Subject: PLEXIGLAS SUPPORT VIBRATION

Models: MULTISTRADA 1200 MODEL YEAR 2013 (all versions)

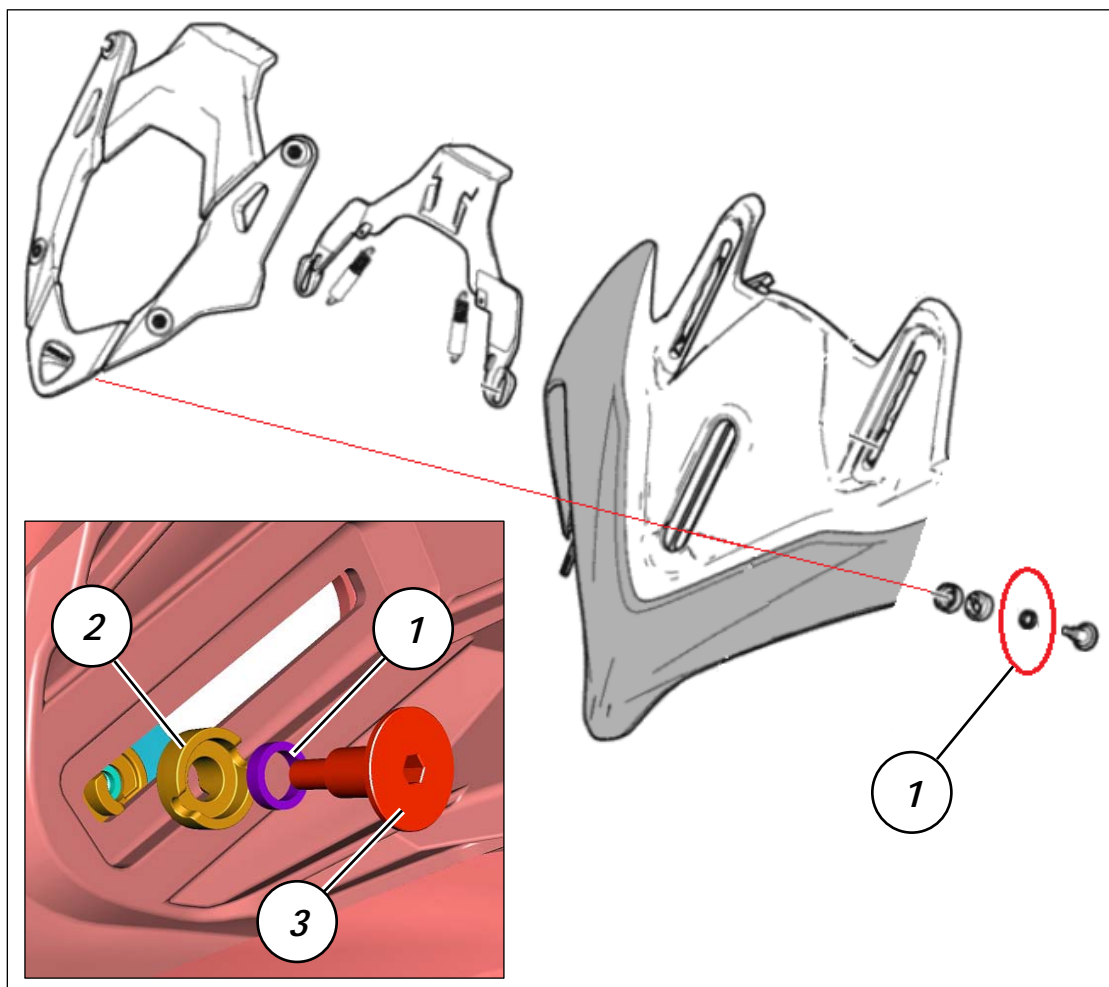
The Multistrada 1200 Model Year 2013 belonging to the first produced lot could feature a vibration in the Plexiglas support when riding the bike.

The play that could cause such vibration can be also checked with stopped motorcycle.

To prevent this, replace original equipment **rubber pad (1)** placed between **special screw (3)** and **bushing (2)** with a new rubber pad (part. no. 86611132A).

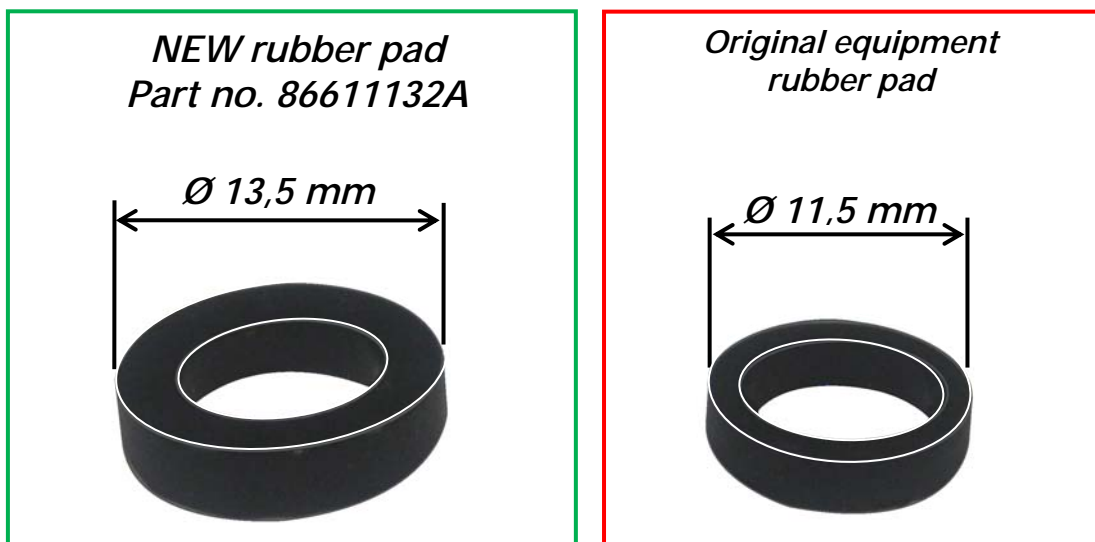
The new rubber pad (part. no. 86611132A) can be distinguished from the one supplied with the original equipment (external diameter 11.5 mm) as it features a larger external diameter (the external diameter being now 13.5 mm):

Remove the bike headlight fairing to reach the Special screw (3). Afterwards tighten such screw to a torque of 5 Nm ± 10%.

The new rubber pad - part no. 86611132A. - has been introduced on the production line starting from VIN no. ZDMA300AADB005278.
